PJM Manual 12: Balancing Operations v52 Revision Summary

M-12 Version 52 Revisions

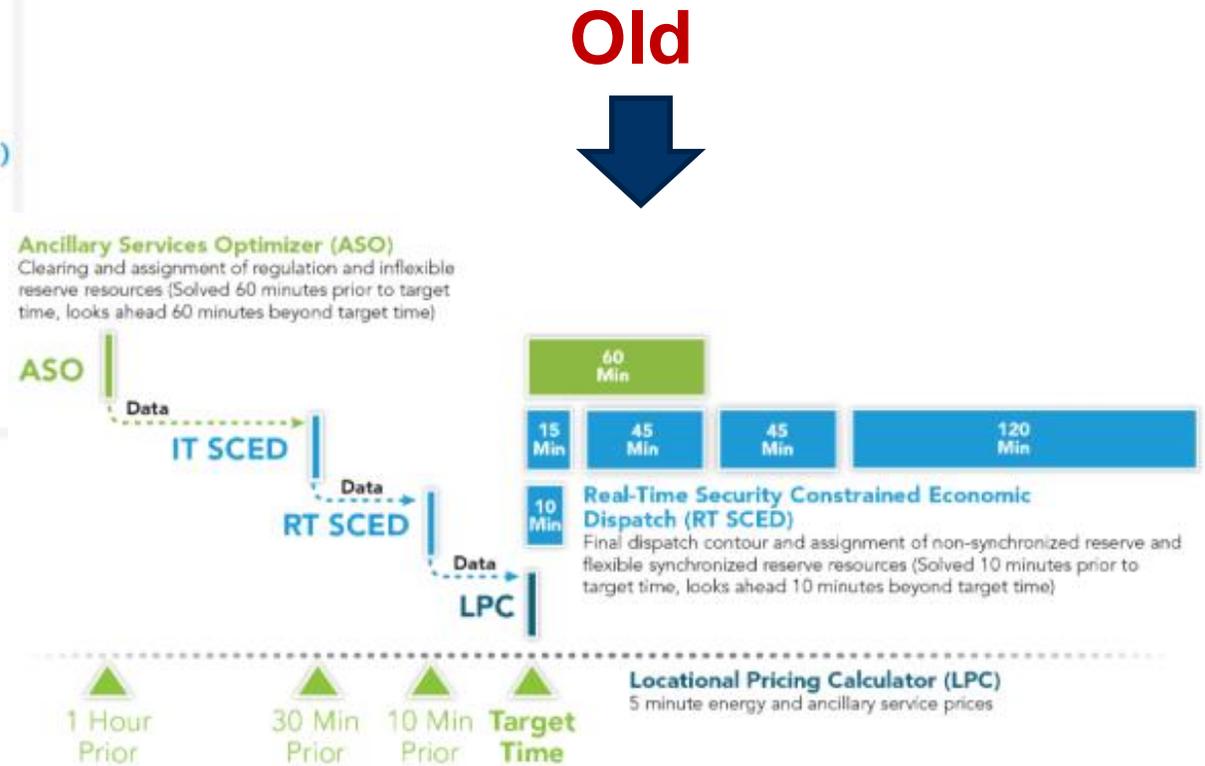
- Updated Exhibit 5: Real Time Market Application Process Flow to match M-11

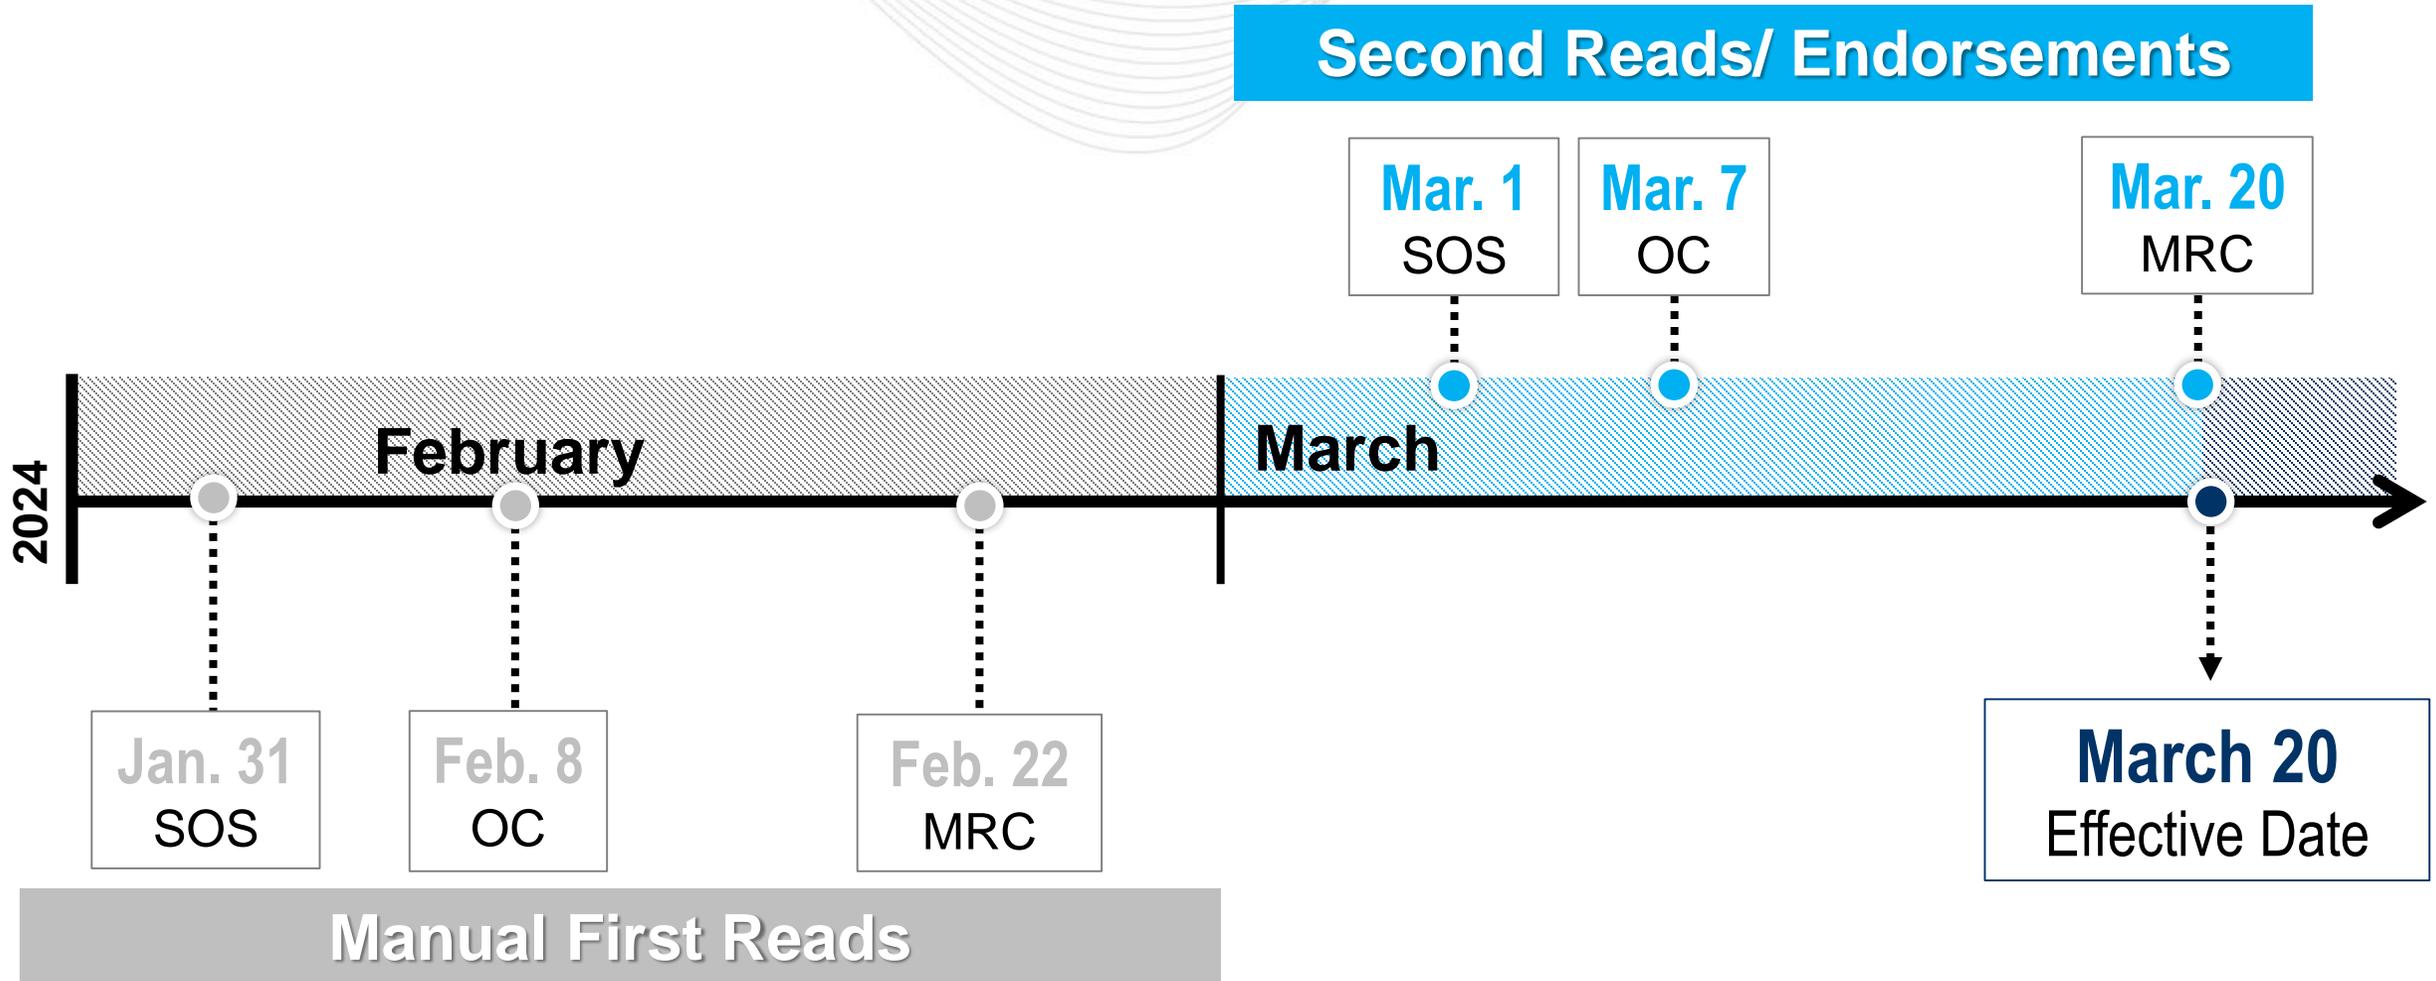
- Notes modified to include hybrid resources

3: An intermittent or hybrid resource's Economic Minimum shall represent the lowest operating MW point of the resource.

4: An intermittent or hybrid resource's Emergency Minimum should be set to 0.
